Amendment/Response to Office Action**REMARKS/DISCUSSION OF ISSUES****Objections to drawings**

ANNOTATED SHEET, FIG. 2

FIG. 2

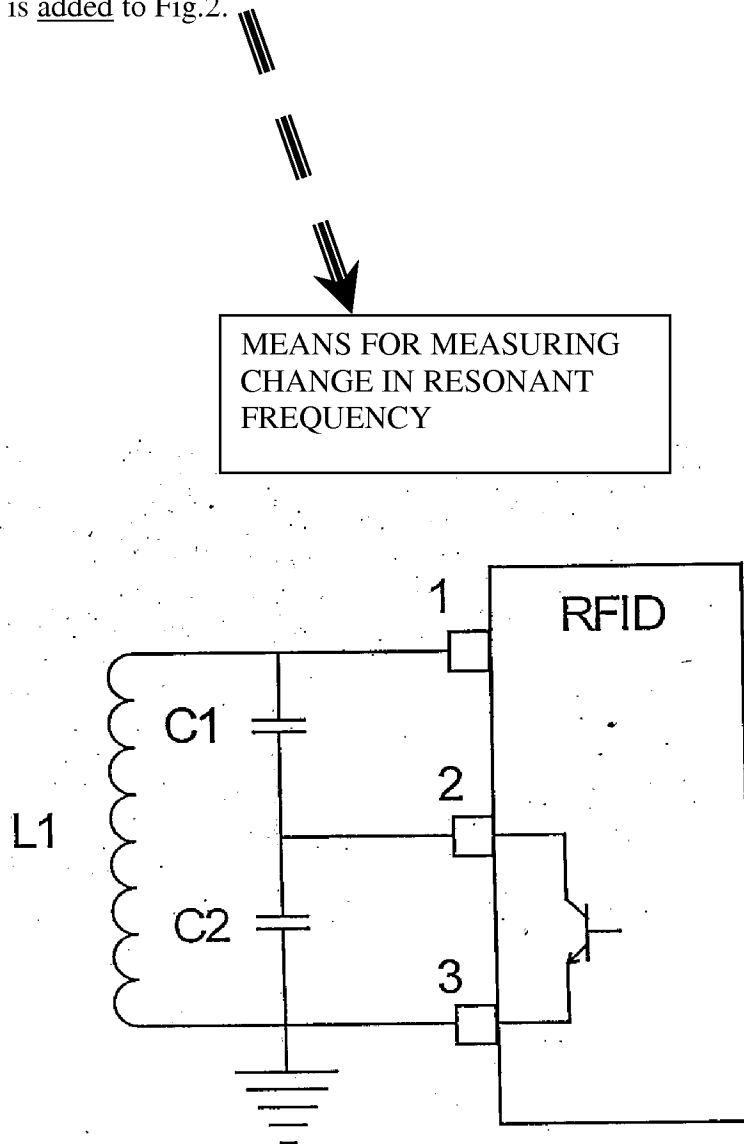
The drawings were objected to by the Examiner under 37 CFR 1.83a. The Applicants have amended the drawings and the claims to comply with the objections as follows:

(a) The L-R-C circuit was replaced in claims by L-C circuit. The L-C circuit is shown in the drawings. For example, Fig. 2 shows L1 and C1 interconnected components representing L-C circuit of the present invention. A detailed description of this L-C circuit is provided in the specification, for example on page 19, Fig 2 brief description.

(b) The Examiner has requested to show the means for measuring the change in resonance frequency in Figures. The means for measuring the change in resonance frequency are shown in the attached amended Fig. 2 as a rectangular labeled box. As per 37 CFR 1.83a, Content of drawing, "...conventional features disclosed in the description and claims, where their detailed illustration is not essential for a proper understanding of the invention, should be illustrated in the drawing in the form of a graphical drawing symbol or a labeled representation (e.g., a labeled rectangular box)." Support for the means for measuring the change in resonance frequency shown in Fig. 2 is found on page 33, paragraph 4; pages 34-36; page 39 paragraphs 4 and 5. No new matter is introduced by this amendment of Fig. 2.

A labeled rectangular box representing MEANS FOR MEASURING CHANGE IN RESONANT FREQUENCY is added to Fig.2.
